Report to Planning and Environment Committee

Subject: 1170 Fanshawe Park Road East Inc. (c/o Brock Development Group Inc.)
1170 Fanshawe Park Road East
File Number: Z-9713, Ward 5
Public Participation Meeting

Date: April 30, 2024

Figure 4. Conceptual Site Plan

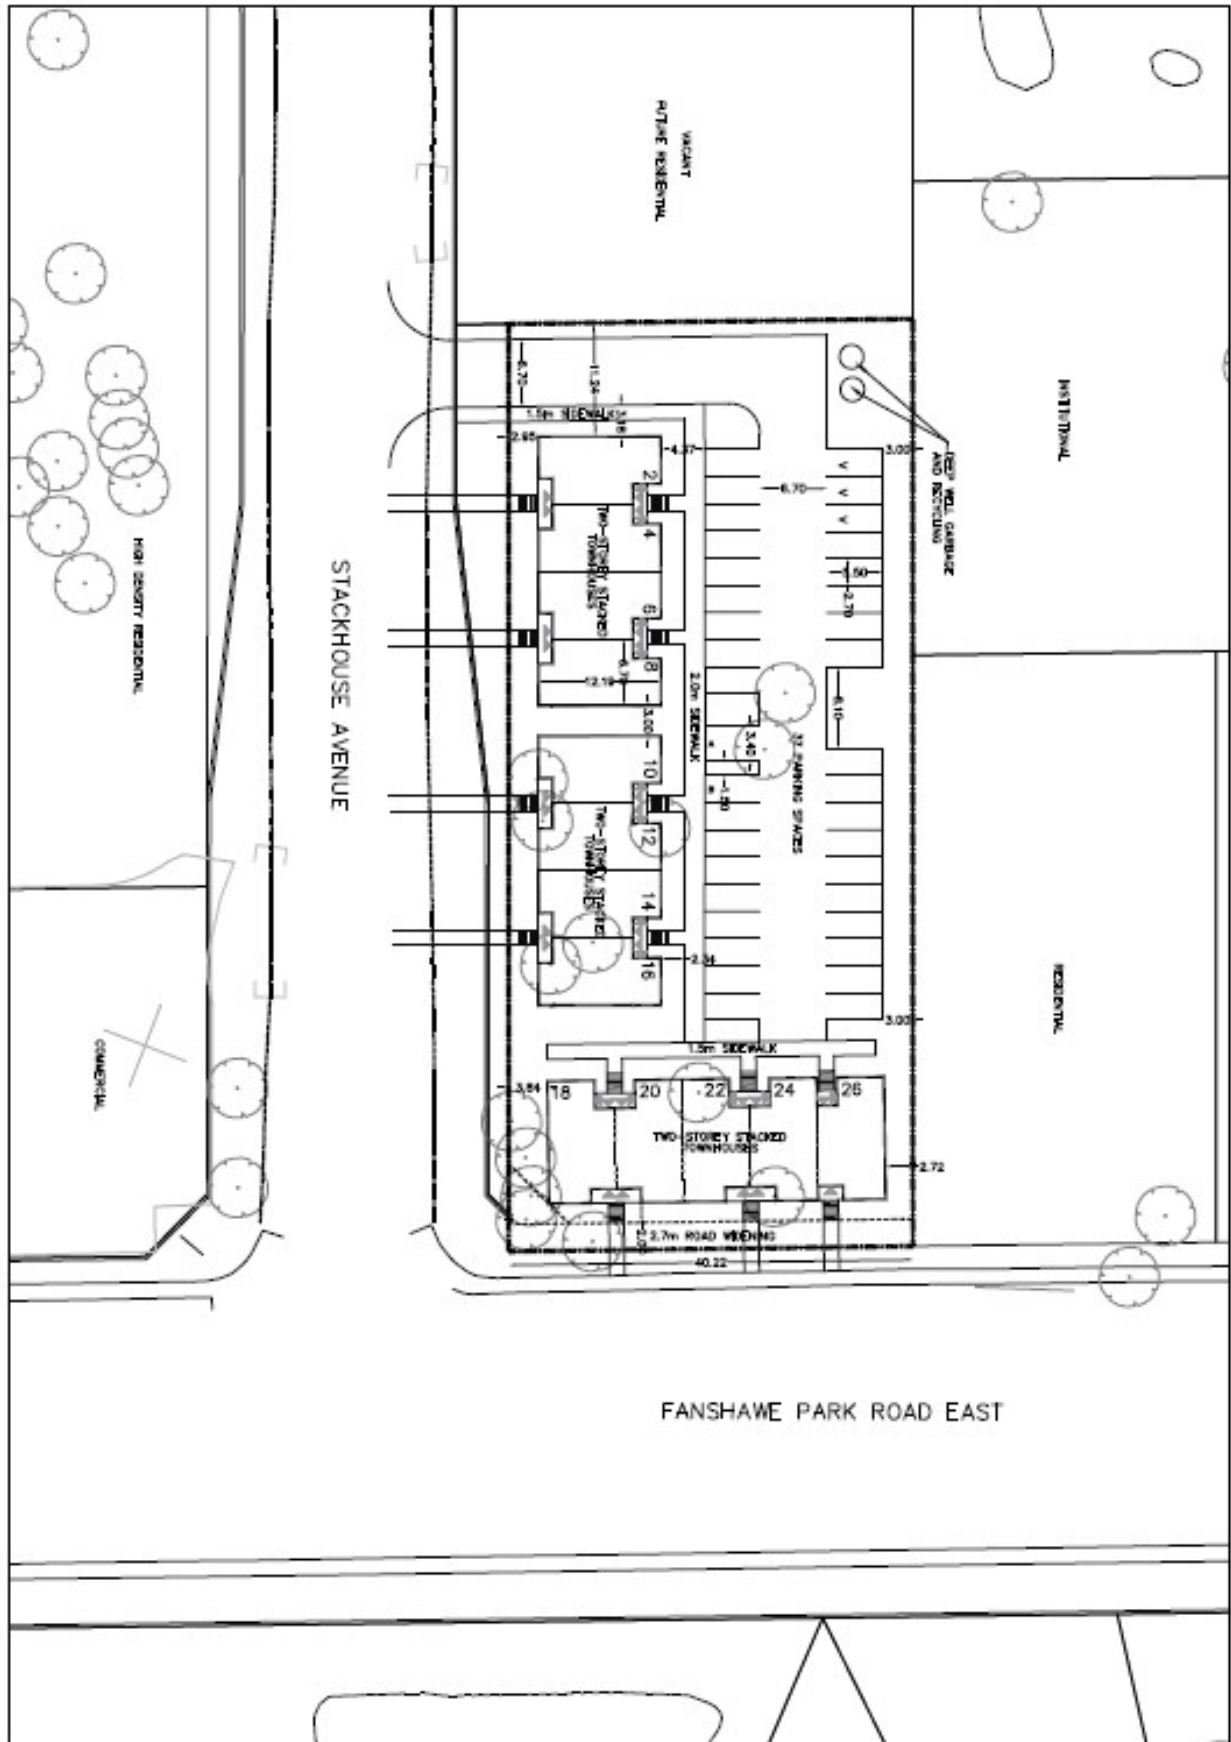
- Consider reducing the number of surface parking spaces provided in favour of an at-grade common outdoor amenity space and more landscaped area [TLP Policy 270, 295].
- Extend the 1.5m walkway proposed in front of Units 18-26 (Block C) to the street [TLP Policy 255, 268].
- Provide a public sidewalk or private walkway along the Stackhouse Avenue frontage and ensure the walkways proposed on-site connect to this sidewalk [TLP Policy 255, 268].
- Include facilities for temporary bicycle storage (bike racks) to promote active transportation [TLP Policy 280].
- Provide landscaping to mitigate headlight glare into the windows of the below-grade level.
- Provide a full set of dimensioned elevations for all sides of the proposed buildings with materials and colours labelled. Further comments may follow upon receipt of the elevations.

- The proposed waste storage setup is generally not supported by the City's Solid Waste Management team due to the proposed storage containers and the proposed location. The City does not service deep waste recycling bins through our contractor, as such recycling will have to be managed privately. For garbage, crews can only collect bins that can be lifted with a front-end fork truck, which are typically forked bins such as Earth Bin and EnviroWorx. As well, municipal waste collection vehicles strongly prefer having a turnaround area on site and will not reverse onto a public roadway (Stackhouse Avenue in this case).

- Identify the proposed snow storage locations and ensure that they do not conflict with landscape planting or the common outdoor amenity space.
- Provide all necessary fire department access information in accordance with Figures 6.3, 6.4, and 6.5 of the Site Plan Control By-law.

- Extend the sidewalk along the rear of units 18-26 to connect to Stackhouse Avenue.
- Enlarge all 1.5 metre sidewalks to be 1.8 metres for accessibility purposes. Refer to the Accessibility Checklist for more information.

- Ensure a 1.5 metre setback is provided between the rear property boundary and the drive-aisle to provide for landscape planting.
- Widen the 2.0 metre sidewalk running along the rear of units 2-16 to be at least 2.1 metres as this sidewalk is abutting a parking area.

- Site grading is to consider the ultimate urban cross section of Stackhouse Ave.
- Given the building arrangement and setbacks proposed, the consultant's options for routing overland flow are limited due to the grading of the fronting ditches. Please see as-con 20154; OLFR should be ultimately be directed to Fanshawe Park road, and not north via Stackhouse Ave.

- Please confirm with geomatics for the road widening dedication required. The concept plan shows the road widening of 2.7 meter, whereas the required widening is less than the identified on the concept plan. Presently the width from centerline of Fanshawe Park Road East at this location ranges from 18.302m at the westerly limit to 18.286 at the easterly limit as shown on 33R-17525 (Part 6 on 33R-17525 was dedicated by Bylaw s.-5835-8). Therefore, an additional widening of 1.698m is required at the westerly limit and an additional widening of 1.714m at the easterly limit to attain 19.5m from c/l.
